PREVOST

WARRANTY BULLETIN

WB14-45B

DATE :	OCTOBER 2014	SECTION :	06 - Electrical
EXPIRATION:	OCTOBER 2016		
SUBJECT :	R49 "ACM RELAY" REMOVAL

Figure 3 : H-series vehicles

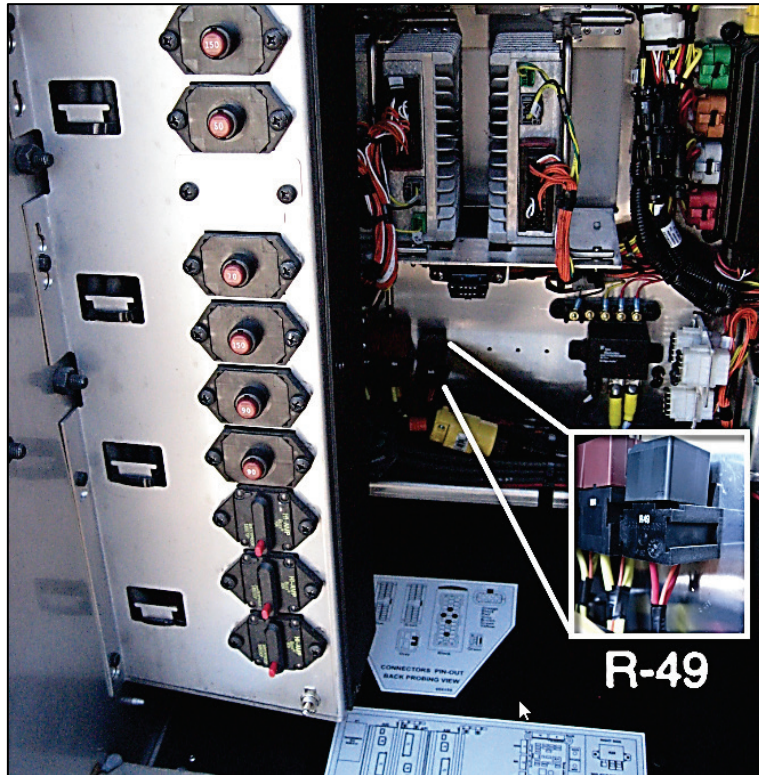
2. Locate R49 relay.

On *H series* vehicles, relay is located on the lower left section of the rear wall. (Fig. 3)

Figure 4 : X-series vehicles

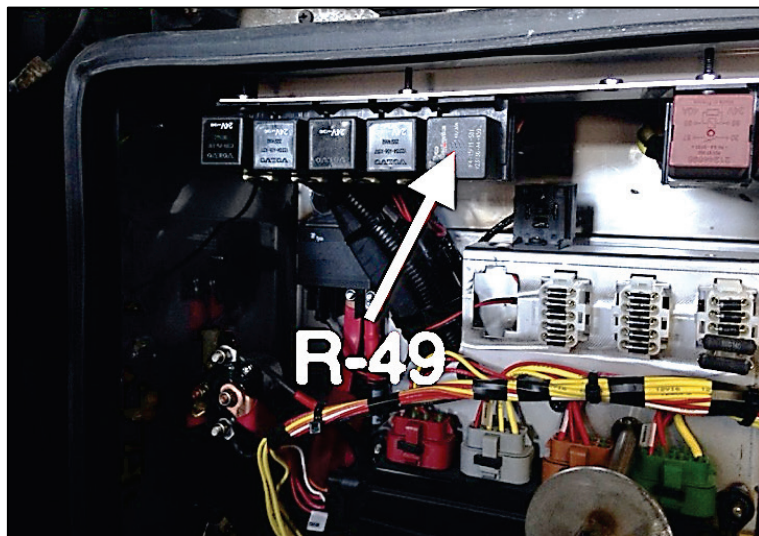
On *X series* vehicles, remove the vertical cover of the electrical compartment above the battery compartment.

Relay is located in the upper left corner of the electrical compartment. (Fig. 4)

Figure 5: Heat shrink tube. X-Series shown

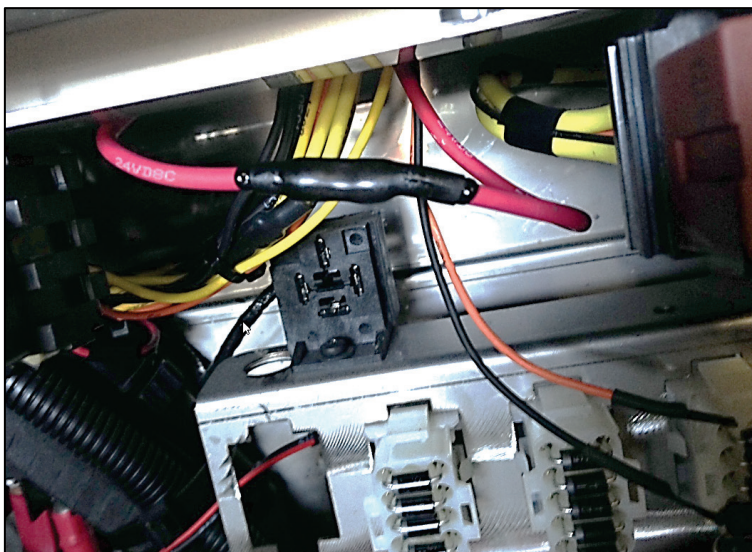
Slide a 2 in. length of shrink tube # 560784 over one of the red **24VD8** cable.

Connect cables **24VD8** and **24VD8C** with butt splice terminal #562230.

Crimp and solder the connection.

Slide shrink tube over crimped terminal and heat to seal connection. (Fig. 5)

Protect remaining smaller gage wires 425 and 00B with 2 in lengths of shrink tube #561918. (Fig 5)

Figure 6 : Decal 068891I

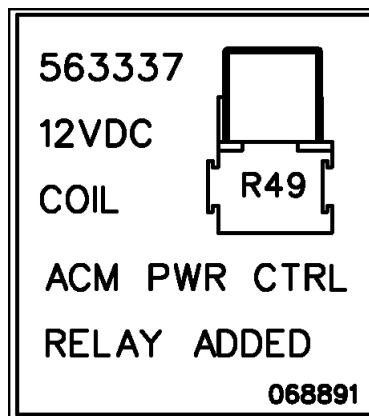
Remove decal "ACM PWR RELAY ADDED" on compartment main decal.
